Subject: Request for Proposal 2 - Changes to Backfill at Interior Retaining Walls

Project Name: Camden Rockport Middle School

Potential Change Order #007

Request for Proposal No. 002

SCALE: NTS
 DATE: 08/15/18
 REV: SK-C1
 CLARIFICATION
 SKETCH

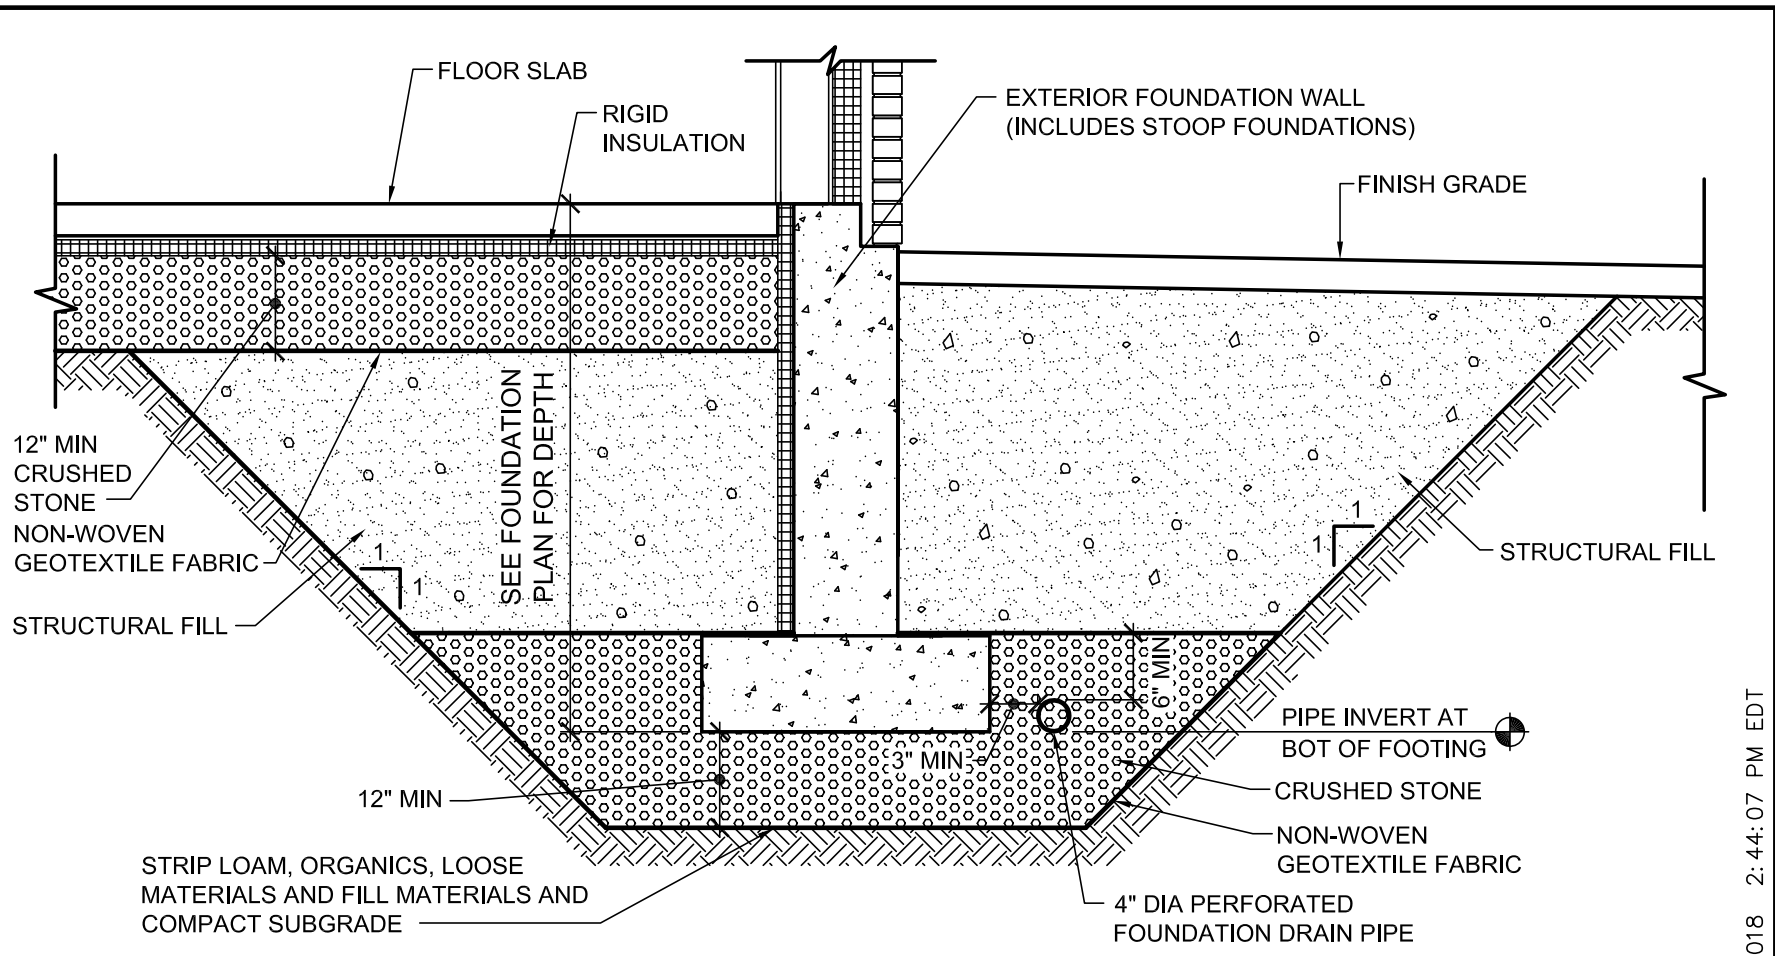
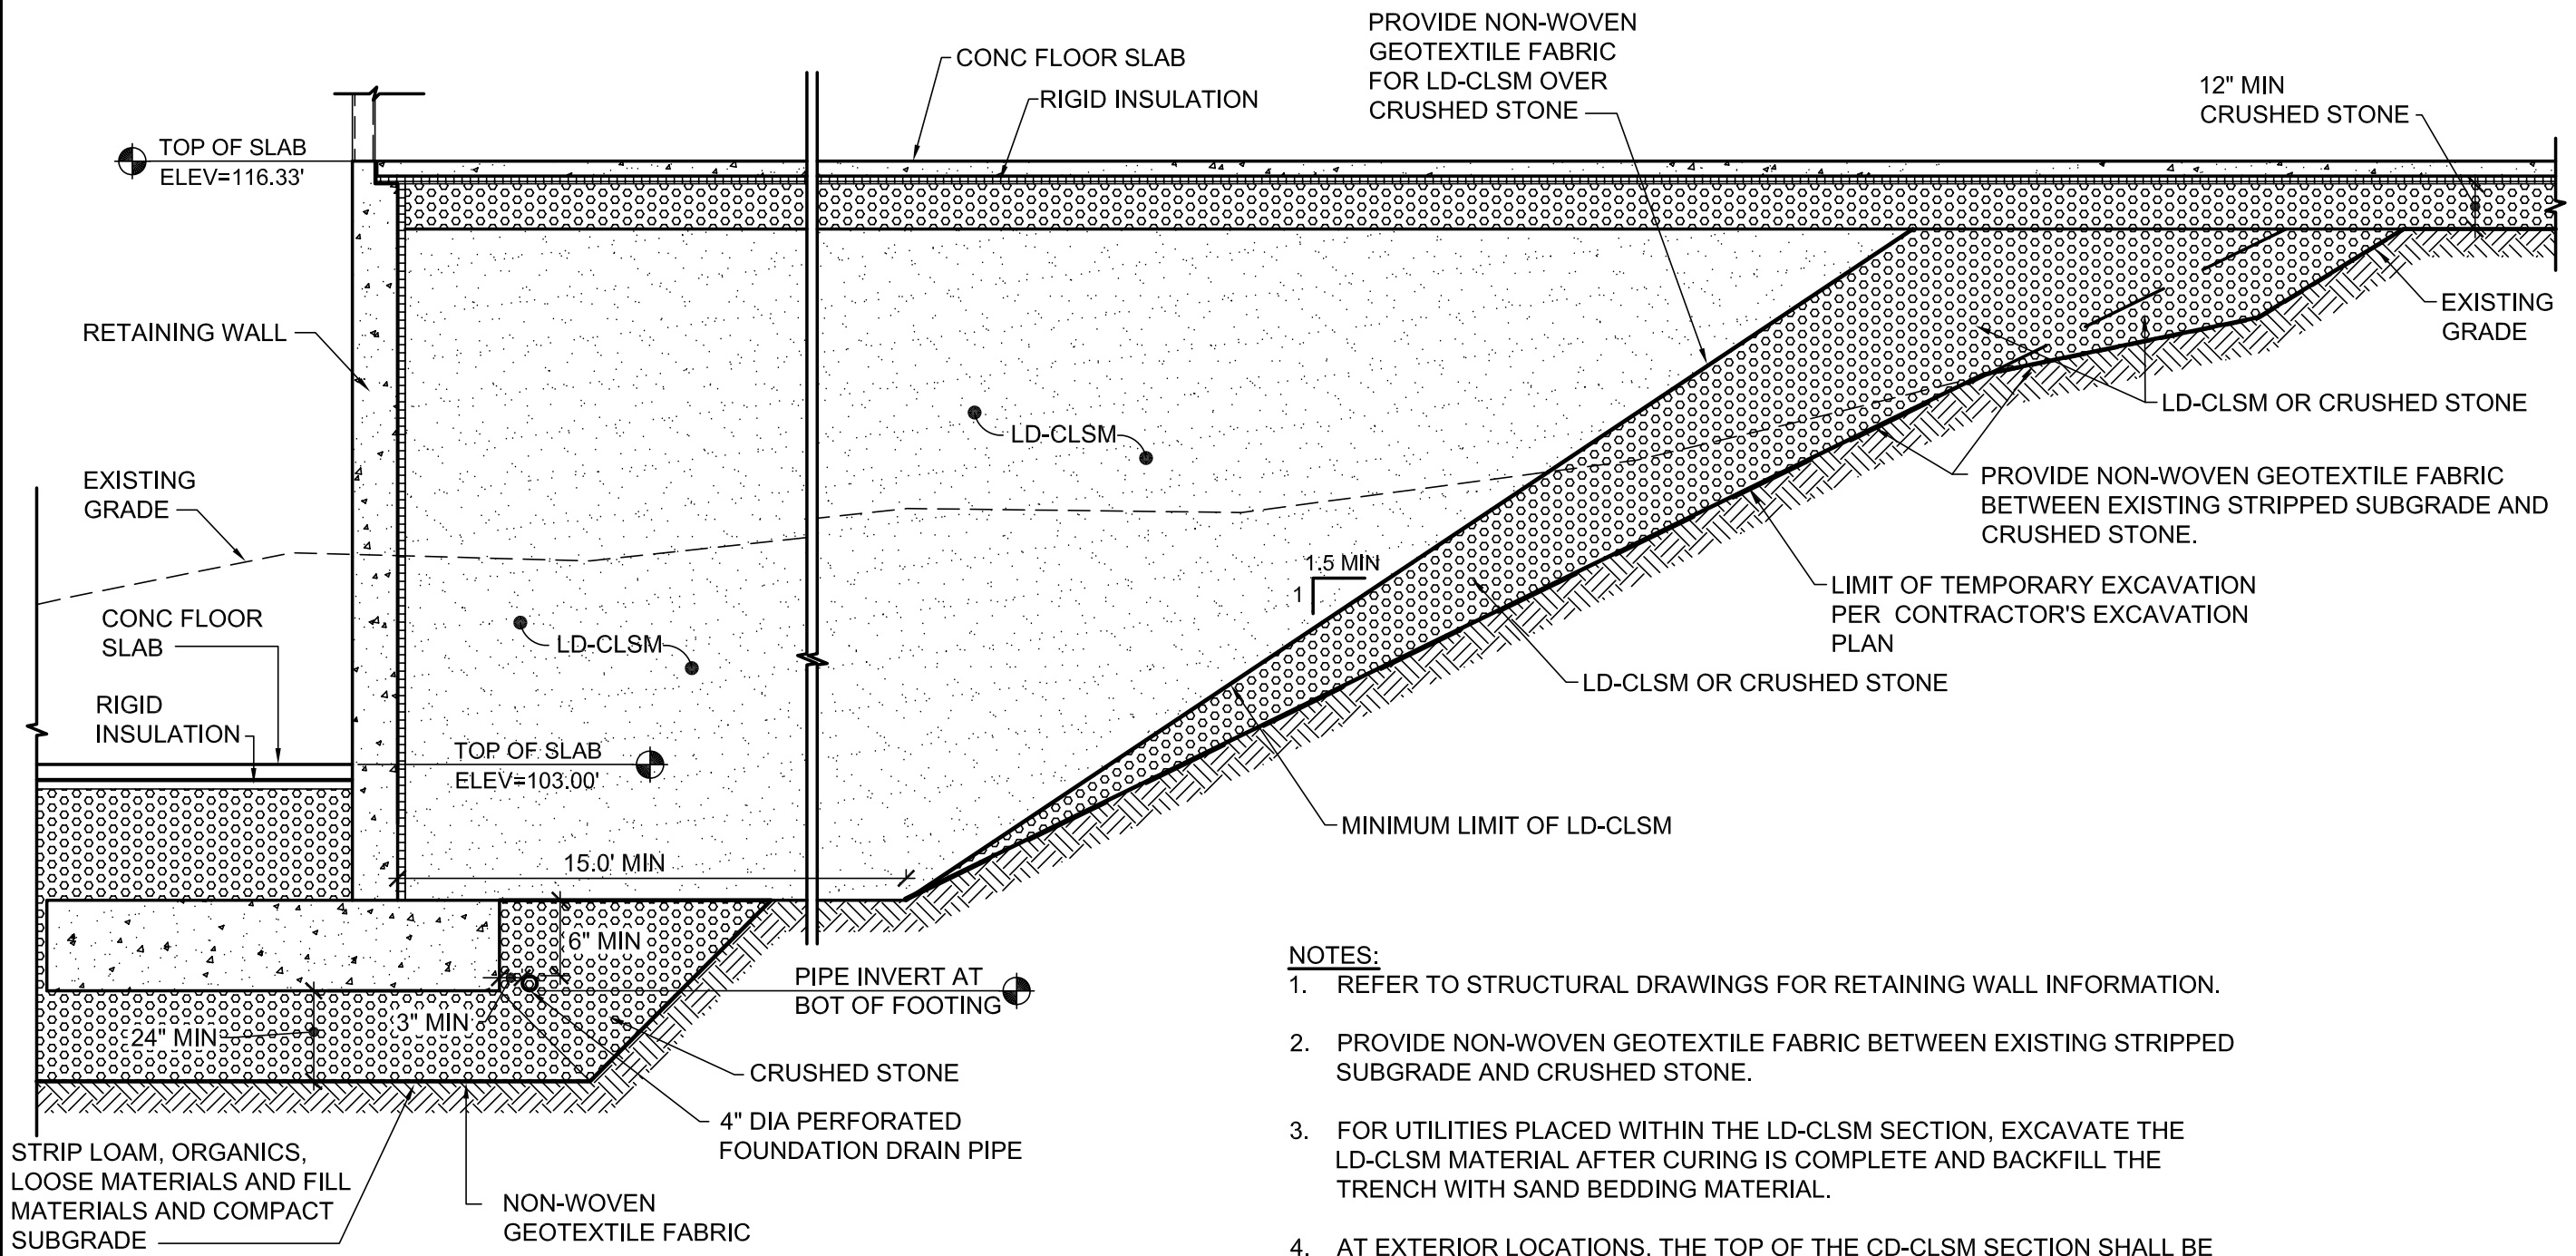
5. Structural fill material may also be used in lieu of base course for backfill at the exterior foundation wall to the limits indicated on the Foundation Preparation and Drain detail (1/C-502). Structural fill material shall meet requirements indicated on the Clarification Sketch SK-C1.

6. Structural fill material may be used for backfill along the interior wall between column lines KK-50 and MM-39, as depicted on Clarification Sketch SK-C1. Structural fill material shall meet requirements indicated on the Clarification Sketch SK-C1.

1. Structural Fill: Naturally or artificially well graded mixture of natural or crushed gravel, crushed stone, and natural or crushed sand free from vegetable matter, lumps, or balls of clay and other deleterious substances and meeting the following gradation:

Note: Maximum particle size shall be limited to 3 inches within 2 feet of foundation walls, footings, and floor slabs.

1 FOUNDATION PREPARATION - RETAINING WALL

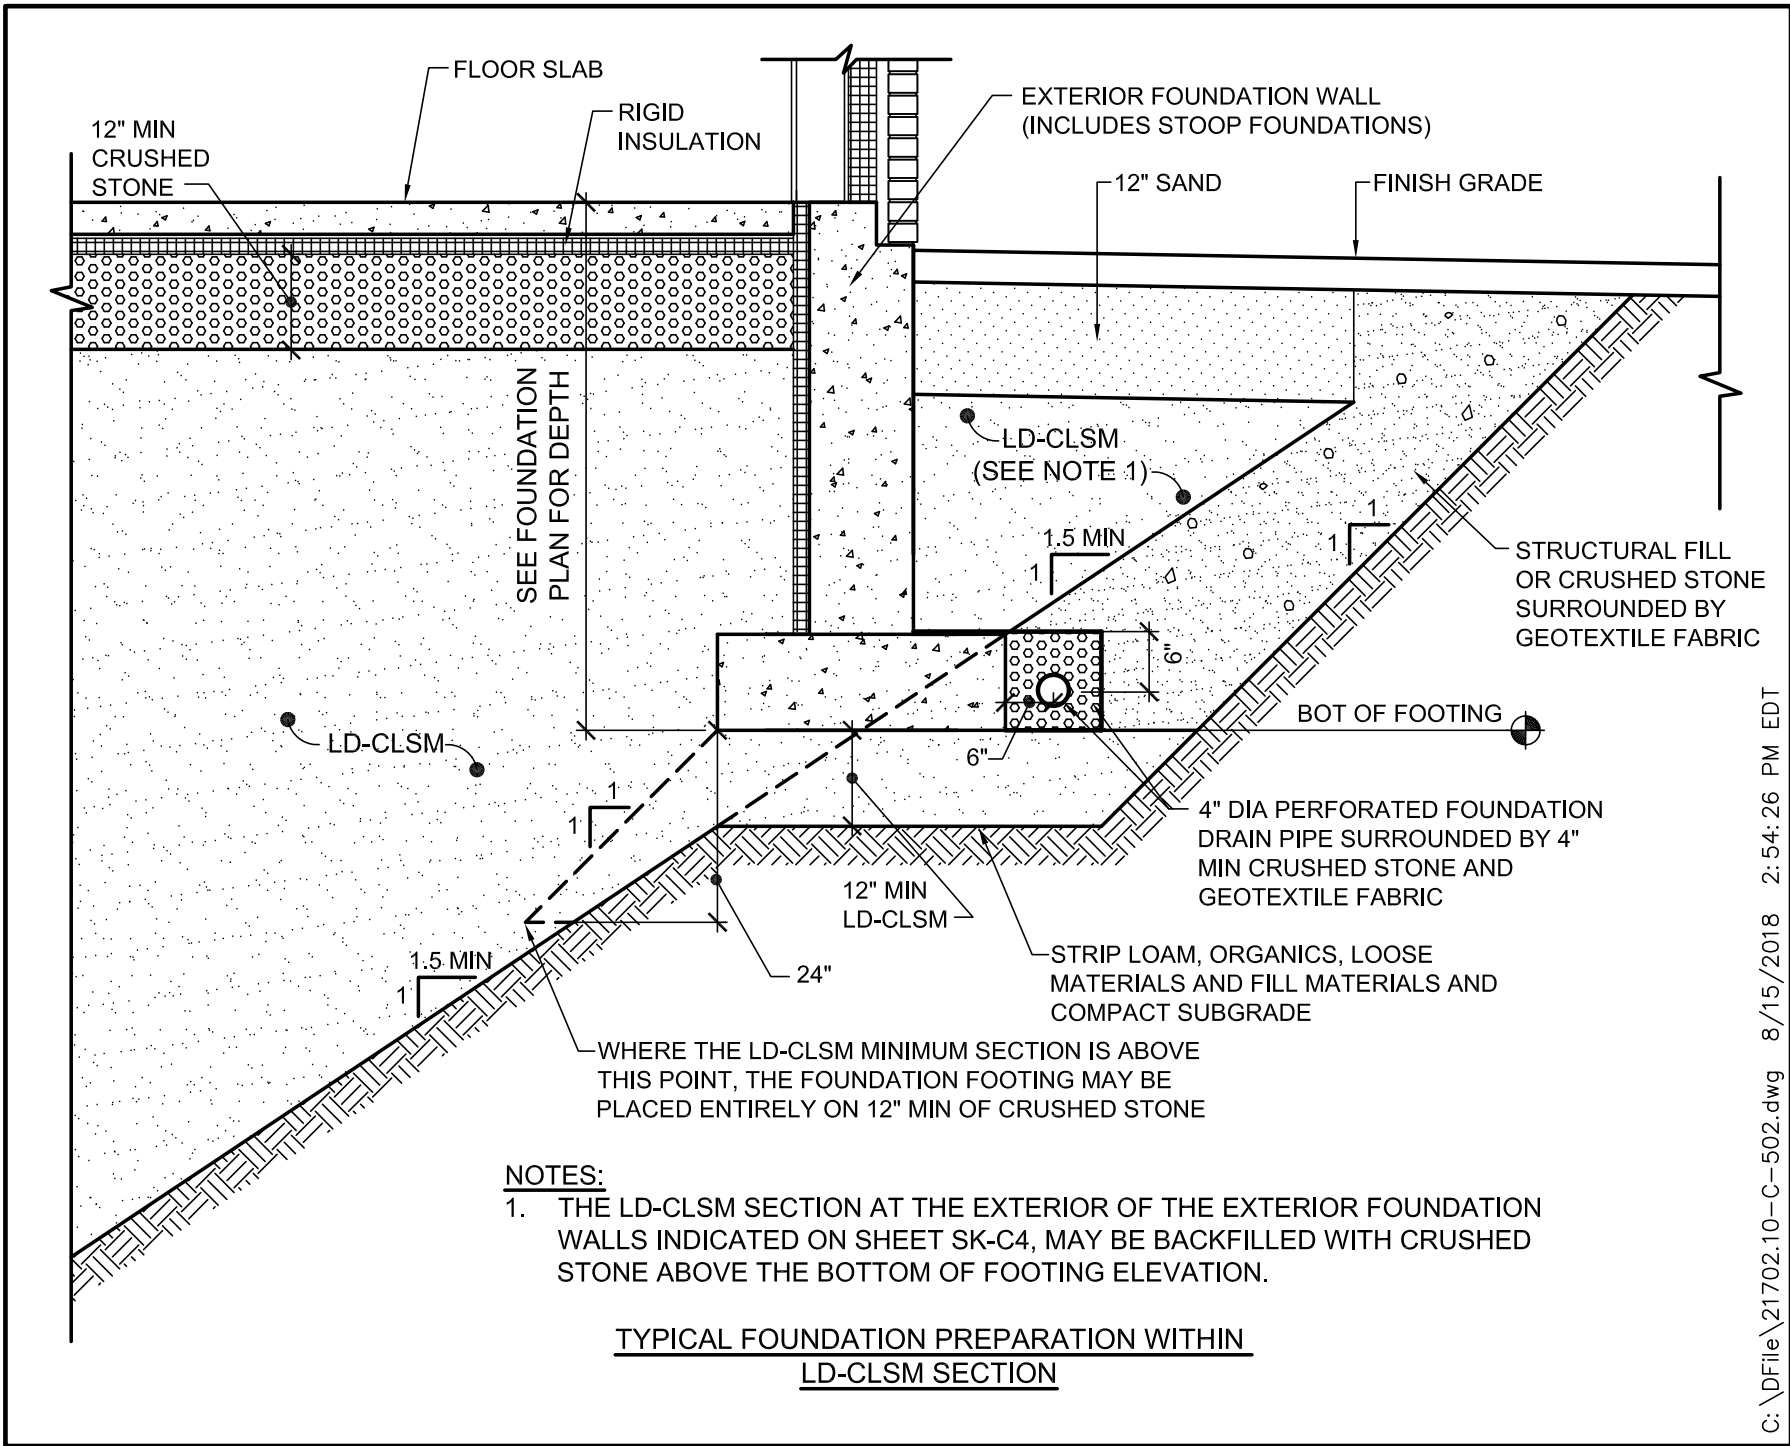
1. Delete crushed stone backfill and geo-grid reinforcing around reinforced concrete retaining and foundation walls.
2. Provide low density controlled low-strength material (LD-CLSM) at reinforced concrete retaining and foundation walls. Refer to SK-C2, SK-C3, SK-C4 and SK-C5 for extent of LC-CLSM material

- NOTES:**
1. REFER TO STRUCTURAL DRAWINGS FOR RETAINING WALL INFORMATION.
 2. PROVIDE NON-WOVEN GEOTEXTILE FABRIC BETWEEN EXISTING STRIPPED SUBGRADE AND CRUSHED STONE.
 3. FOR UTILITIES PLACED WITHIN THE LD-CLSM SECTION, EXCAVATE THE LD-CLSM MATERIAL AFTER CURING IS COMPLETE AND BACKFILL THE TRENCH WITH SAND BEDDING MATERIAL.
 4. AT EXTERIOR LOCATIONS, THE TOP OF THE CD-CLSM SECTION SHALL BE PLACED TO 18 INCHES BELOW FINISH GRADE. PROVIDE 12 INCHES OF SAND AND 6 INCHES OF PLANTING SOIL OVER THE CD-CLSM SECTION.
